Benjamin Naiman, Capt.
25 Pinsker Str.
Petah-Tiqva, Israel.

Petah-Tiqva, March 30-th, 1956.

Remington Arms Company, Inc.
Ilion, N.Y., U.S.A.

FIG 3

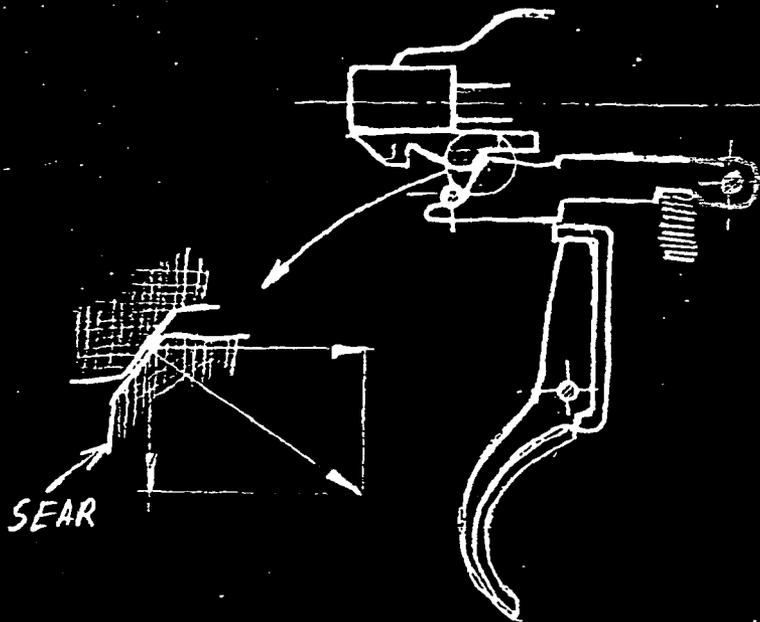
The disappointment came from the trigger action and here is the story: On the very day of the purchase, after several "dry shots" at home, the bolt got stuck and would not lock unless forced brutally. The safety lever would not function. The stock removed, the surface of the firing pin head was found to be riding over the sear surface. On further dismantling of the trigger mechanism, the cause was revealed: the trigger with the connector have sunk. I cannot state the cause; it was due, presumably to either the poor quality of the trigger alloy or to liberal tolerances (pins placings and such). Fig. No. 3 will illustrate the above.

FIG 4

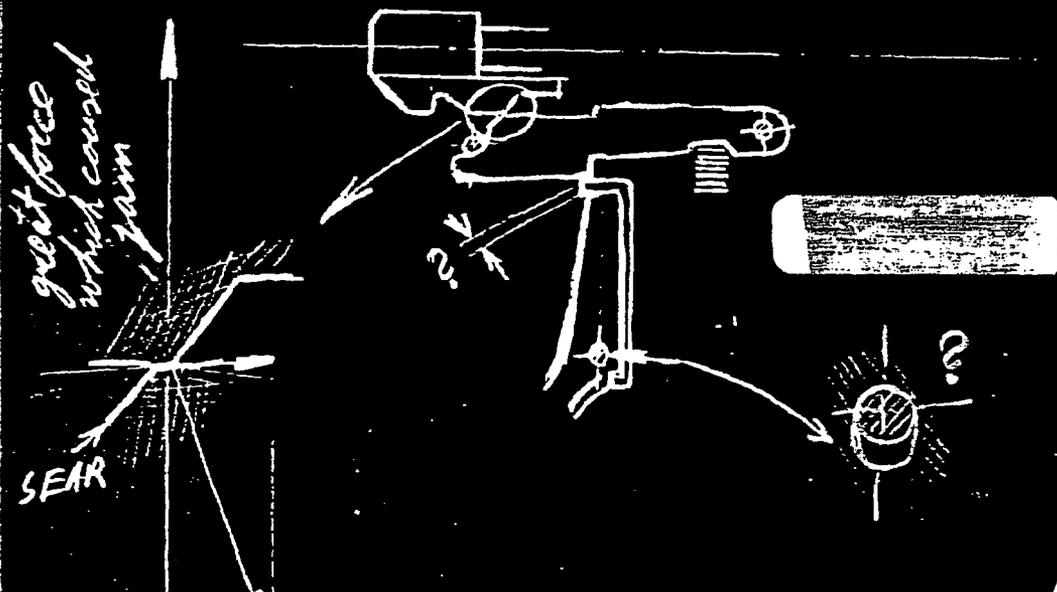
I had to order a new connector with a thicker head and, seeing no reason why it should not be connected to the trigger, I fixed the two bodies together by means of a 1/8" screw. The latter arrangement enabled me to replace the original heavy trigger spring by a lighter one aiming for a lighter pull. Please inform me whether you approve of the above. The click adjustment of the trigger is most convenient but unscrewing the trigger adjusting screw too much, causes the "trigger adjusting ball" to be pushed outside by the spring and removing of the stock becomes necessary. I suggest that the above be eliminated by addition of a thin pin-extension to the "trigger adjusting screw" (see fig. No.4). It proved successful on my rifle.
